UNITED STATES PATENT AND TRADEMARK OFFICE

| APPLICATION NO. | FILING DATE | FIRST NAMED INVENTOR | ATTORNEY DOCKET NO. | CONFIRMATION NO. |
|---|-------------|----------------------|---------------------|------------------|
| 10/697,034 | 10/31/2003 | Rodolphe Lourdel | 0529-1021 | 1105 |

| Office Action Summary | Application No. 10/697,034 | Applicant(s) LOURDEL ET AL. | |

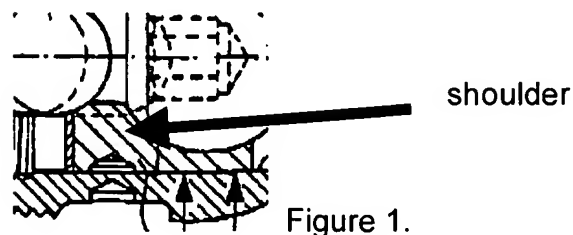
Claims 1-3 and 6 are rejected under 35 U.S.C. 102(b) as being anticipated by Biedermann et al (U.S. Patent No. 5,672,176). Biedermann et al. discloses a device having a connector (5), a connecting rod (15), a screw having a spherical head (1) with a threaded body (2) and an external diameter greater than the spherical head (Fig. 3). Biedermann et al. further discloses a connecting element (16), vertical branches (11 and 12), a U-shaped opening (7), and a locking clip as a blocking device (20) with pressure screw (40). The connecting element has a vertical bore (in the direction of arrow F in Fig. 1). Biedermann et al. also discloses a threaded socket (13). Biedermann et al. also discloses a device where the circular and screw-threaded portions form an internal shoulder. See Fig. 1 below.

The disclosed device also has an internal diameter of the bore smaller than the threaded portion.

Biedermann et al. finally discloses a cylindrical body with threaded screw external surface (46) with an internally opened bore (47) that can form a bearing surface.
